NORTH HALF			
TENNIS COMPLEX			
SOUTH RIVERSIDE PARK			
INDEX # 785469			
BOARD OF PARK COMMISSIONERS WICHITA, KANSAS			
DATE	DRAWN	SCALE	SHEET
2-28-75	TRF & D.R.	1"=10'-0"	3 of 6

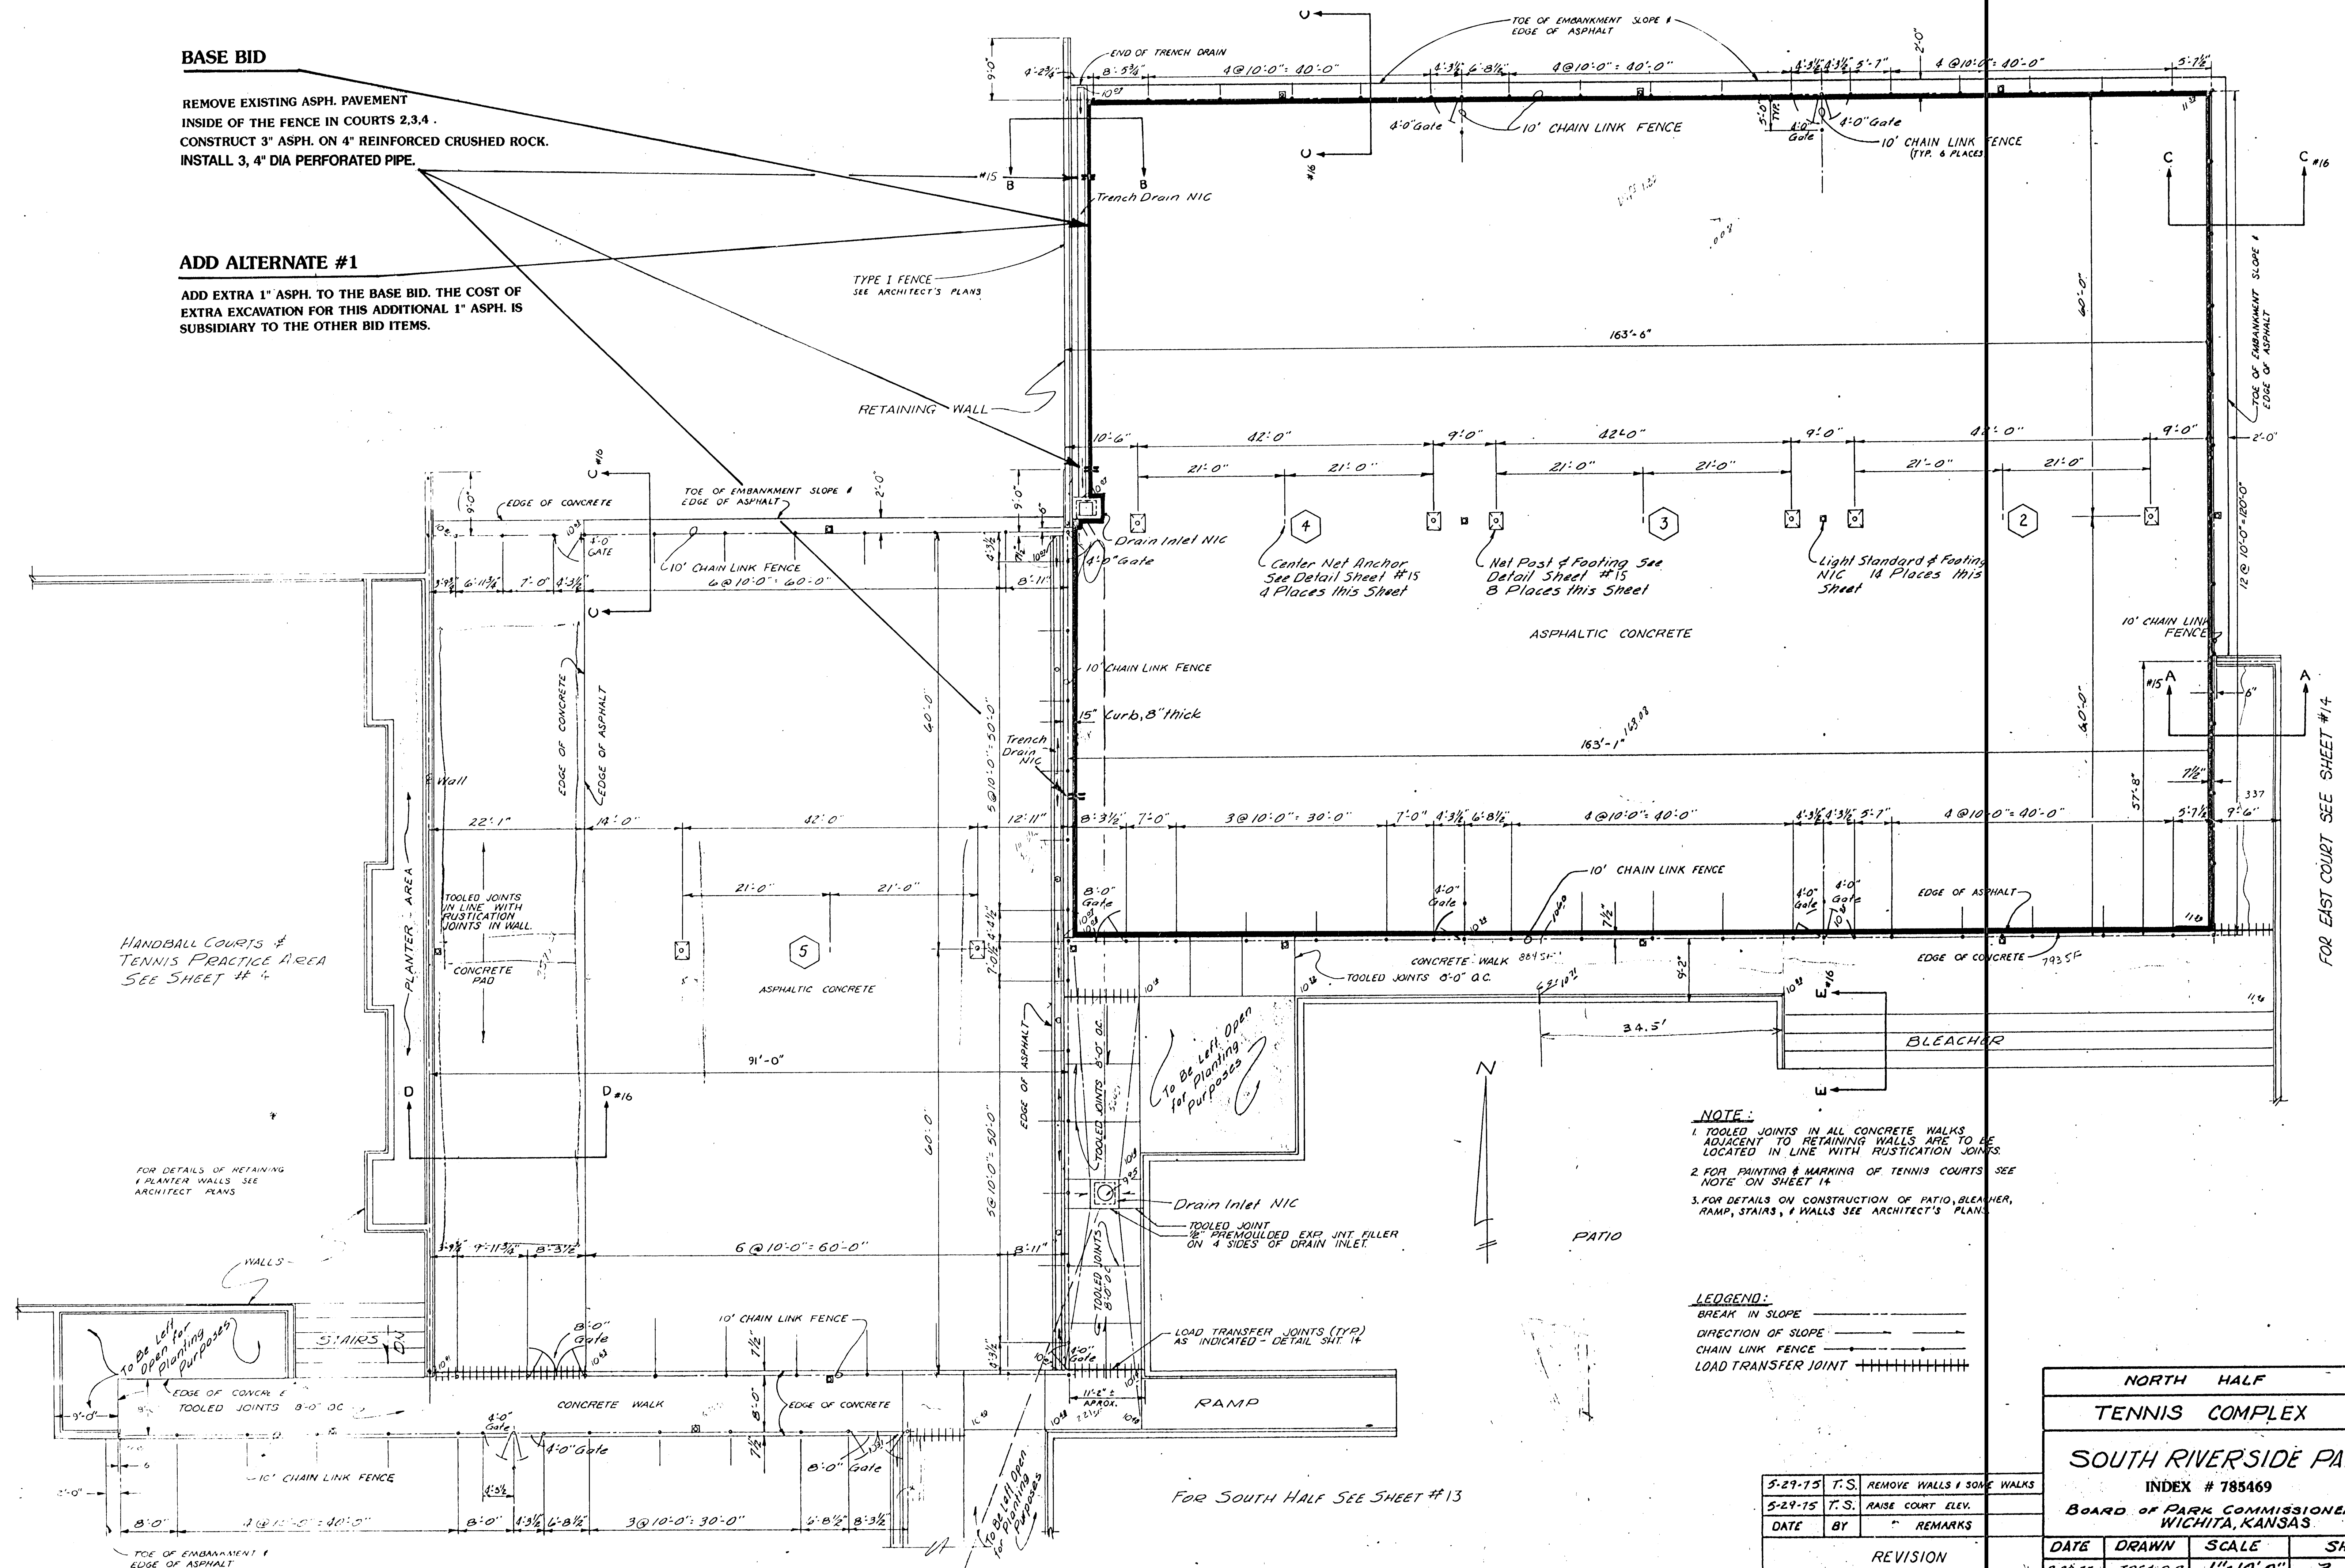
REMOVE EXISTING ASPH. PAVEMENT
INSIDE OF THE FENCE IN COURTS 2,3,4 .
CONSTRUCT 3" ASPH. ON 4" REINFORCED CRUSHED ROCK.
INSTALL 3, 4" DIA PERFORATED PIPE.

**ADD EXTRA 1" ASPH. TO THE BASE BID. THE COST OF
EXTRA EXCAVATION FOR THIS ADDITIONAL 1" ASPH. IS
SUBSIDIARY TO THE OTHER BID ITEMS.**

5-29-75	T.S.	REMOVE WALLS & SOME WALKS
5-29-75	T.S.	RAISE COURT ELEV.
DATE	BY	REMARKS
REVISION
